# Groundwater Application Review Summary Form

Application # G- 19483

GW Reviewer Phillip I. Marcy Date Review Completed: 10/25/2024

**TO:**            **Application G- 19483**

Cross-Section

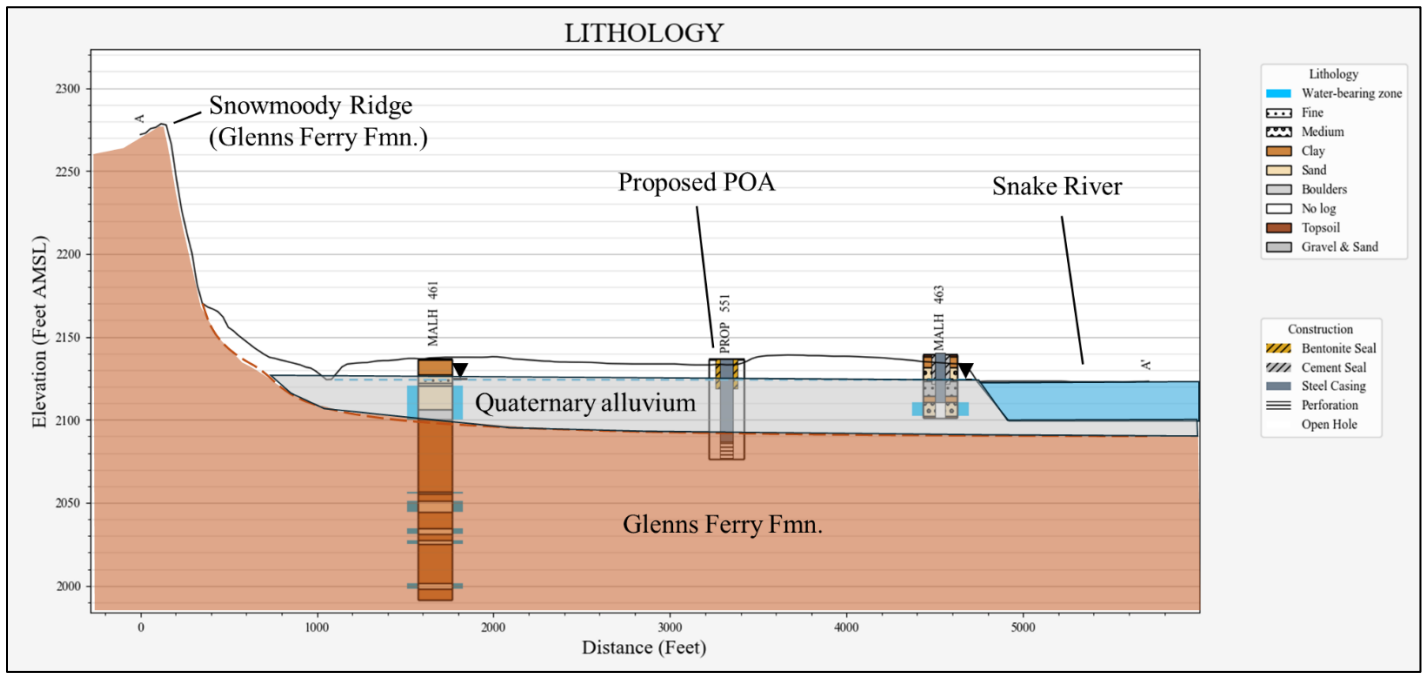
**Basis for aquifer confinement evaluation:** Water levels within wells producing from the Quaternary sand and gravel aquifer are at or near the level at which groundwater was first encountered within the borehole. Overlying silts are not a significant barrier to vertical migration of groundwater, evidenced by seasonal downward percolation of irrigation runoff which causes uptick in water levels during irrigation season (Gannett, 1990).

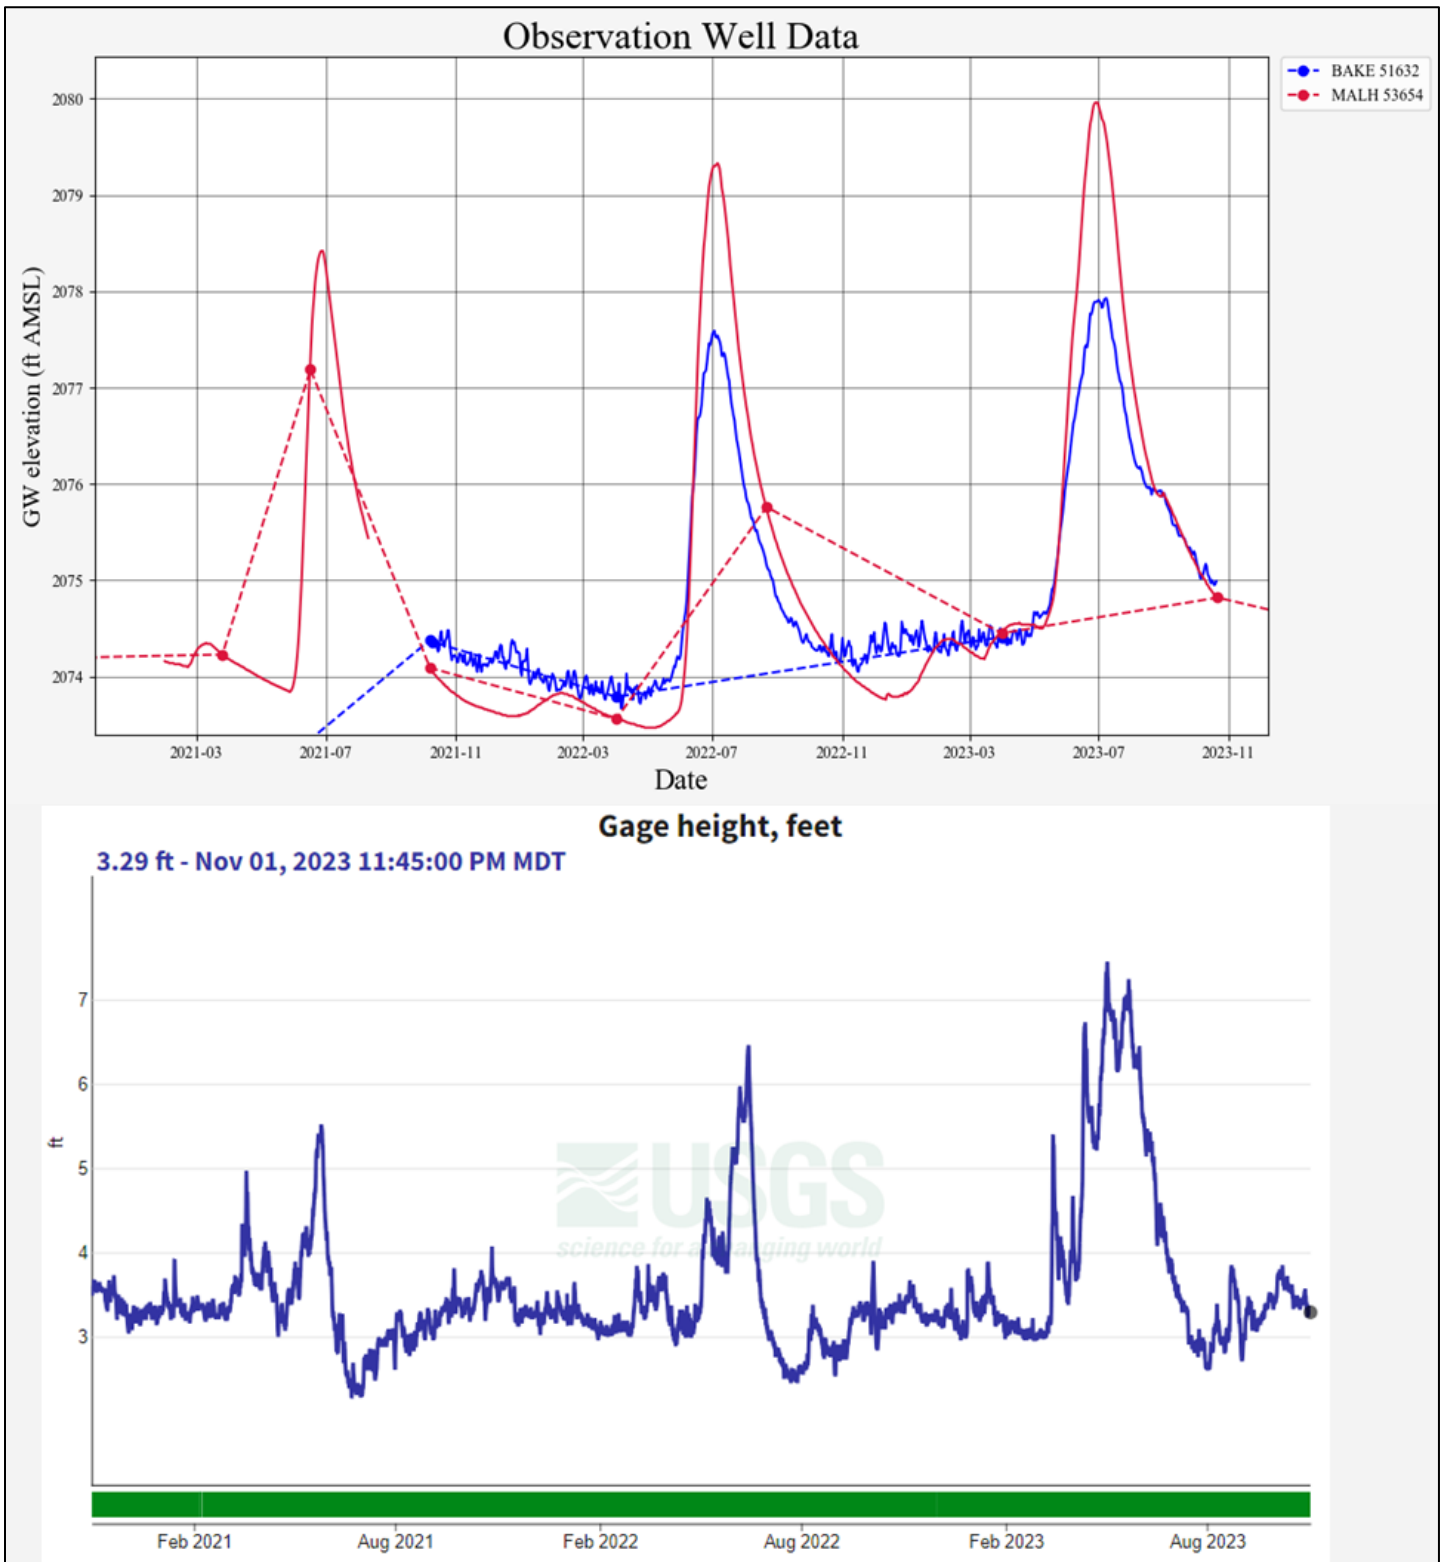
A comparison of groundwater levels in the Farewell Bend area adjacent to the Snake River with the stage of the river itself at Weiser. These sites are several mile north of the proposed POA well, but are in a similar relative position. The relationship between groundwater and surface water trends strongly suggests that groundwater elevations near the river are overwhelmingly controlled by river stage rather than local pumping.
